***TMS320F280x, TMS320C280x, and
TMS320F2801x DSC***

Silicon Errata

Literature Number: SPRZ171J
December 2004–Revised February 2008

Figure 3. Difference Between Expected and Erroneous Operation of START Bit

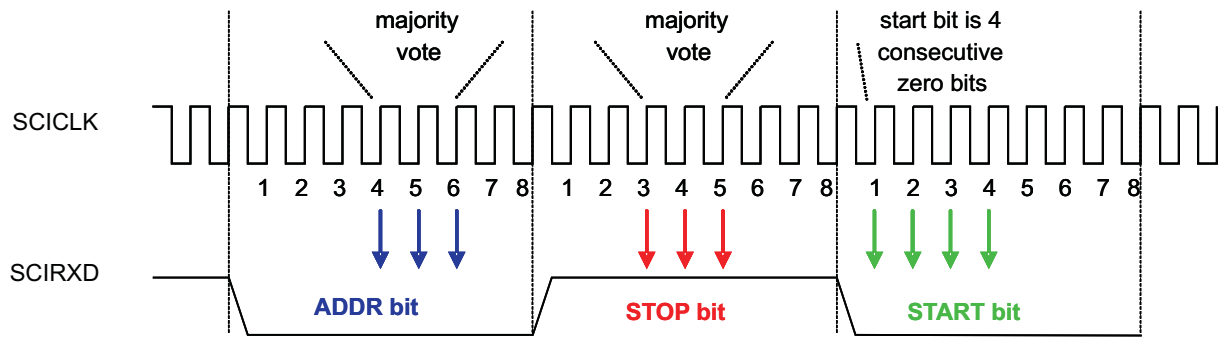
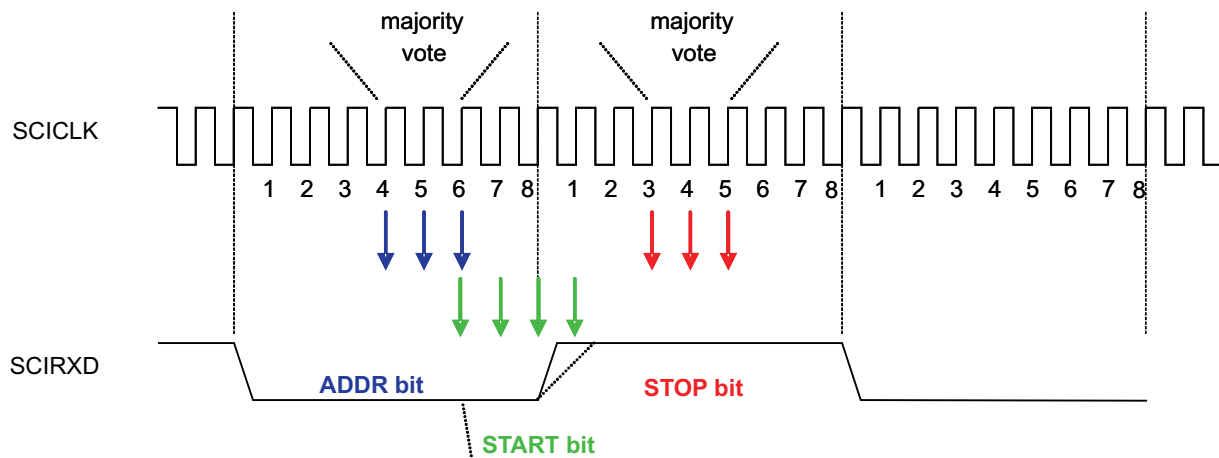
Details SCI does not look for STOP bit after the ADDR bit. Instead, SCI starts looking for the start bit beginning on sub-sample 6 of the ADDR bit. Slow rise-time from ADDR to STOP bit can cause the false START bit to occur since the 4th sub-sample for the start bit may be sensed low.

Workaround(s) Program the baud rate of the SCI to be slightly slower than the actual. This will cause the 4th sub-sample of the false START bit to be delayed in time, and therefore occur more towards the middle of the STOP bit (away from the signal transition region). The amount of baud slowing needed depends on the rise-time of the signal in the system. Alternatively, IDLE mode of the SCI module may be used, if applicable.
